TECHNICAL BULLETIN

MGF

Bull. No: 0016 CDS. ref: M6932bu

HARDTOP POOR FIT TO DOOR GLASS OR REAR DECK - VARIOUS

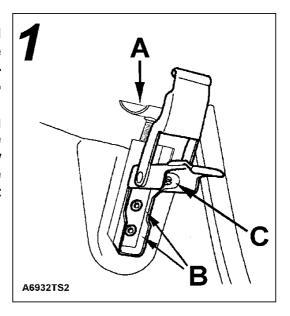
Replace both rear catches for modified catch part number DXW 100200PMA.

The new modified catch has an integral height stop shoe *illustration 1 (A)*, which controls the hardtop height. When adjusted correctly, the height shoe registers on top of the existing body fixing hook. The catch is then clamped to the hook lower as with original catch. As a result the hardtop will compress the rear seal a predetermined amount. This eliminates excessive seal compression which can result in hardtop fouling tonneau deck.

To remove catch first drill out securing rivets (B) with a 5mm drill.
IMPORTANT: use only a short reach drill to prevent penetration of outer hardtop skin on break through.

- 2. Remove loose rivet heads by tilting and shaking hardtop until they can be retrieved from the gaps in the lower B-Post. Ensure all four are removed to prevent complaints of rattles.
- 3. Fit modified catches with special securing rivets, part number DYQ 100340. Ensure the rivet gun used has a nose narrow enough to enter the catch carrier. Failure to ensure this will result in incorrect register of the rivet head.

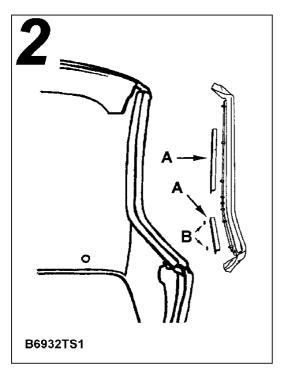
Replace both cantrail seals for modified types DSF 101280PMD (right hand) and DSF 101290PMD (left hand).

These newly introduced 'soft solid' type seals are fitted with special support brackets to improve seal profile and enhance glass to seal fit.

- Remove and discard old seals along with fixings. Clean any remaining adhesive from the base of each B-Post and the front corners of hardtop where previous seals were attached.
- 2. Pre-assemble the new cantrail seals by pressing the brackets *illustration 2 (A)* onto the seal fir tree fixings by hand in the positions shown.
- 3. Press on additional fibre washers (B) to each B-Post bracket fixings (shorter bracket of two).
- 4. Fit seal assemblies to hardtop by pressing fixings into their original locations, start at the 3rd fixing up from the B-Post. Referring to illustration 3, ensure that brackets (A) all register against the inner panel (B), this will then provide the correct profile between seal (C) and hardtop roof (D). Ensure also that cantrail seal run is free from indentations.

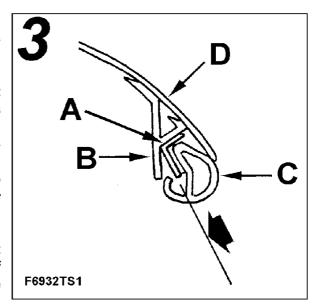
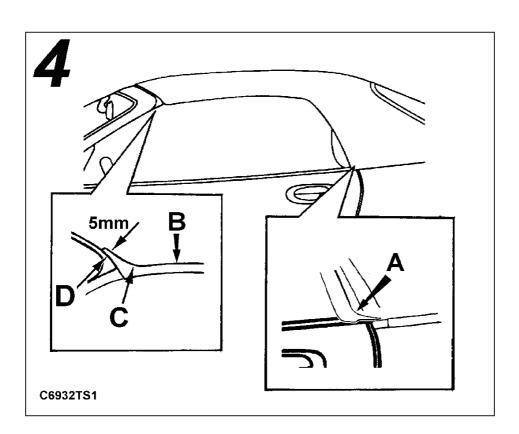
- 5. Apply a small amount of Loctite 406 adhesive to the contact side of the flip seal at base of B-post and glue into position. *Important;* ensure that a good profile around lower corner is maintained see illustration 4(A).
- 6. Apply a small amount of Loctite 406 adhesive to the contact side of the flip seal, top of A-post, and glue to the front of the hardtop. *Important*; ensure outer lip section of seal (B), is pushed in at sides and that a good profile is maintained around front corner (C). Approximately 5mm of seal flip should be visible beyond the front forward edge (D).

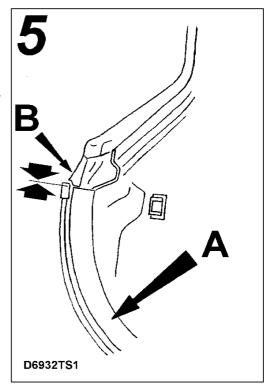
Early vehicles with foam type deck seal, prior to Vin 014487 will require updating to the later 'D' section seal part number DSF101140 PMD.

The later 'D' section seal is a service part only and must only be fitted to vehicles up to hardtop serial number F493. This seal will provide sufficient clearance between hardtop and tonneau deck to prevent direct contact.

- 1. Completely remove and discard old foam seal and any remaining adhesive and road dirt from hardtop.
- 2. Wipe the hardtop seal path with Loctite solvent 7063, this should also loosen any difficult to remove adhesive.
- 3. Obtain new seal part number DSF101140 PMD and wipe entire length of seal with Loctite 7063 paying particular attention to the flat of the 'D' section. Apply 2 continuous beads of Loctite 406 adhesive and apply to the hardtop moulding seal path.

(B). While ensuring that continuous contact is made between the flat section of seal and its mating face of the hardtop *illustration 6 (inset)*, continue to apply until it over laps the cantrail seal on the opposite side. Using a sharp knife, trim

off surplus seal so that a good 'butt' joint is obtained. Apply firm pressure to seal to ensure a good bond is made.
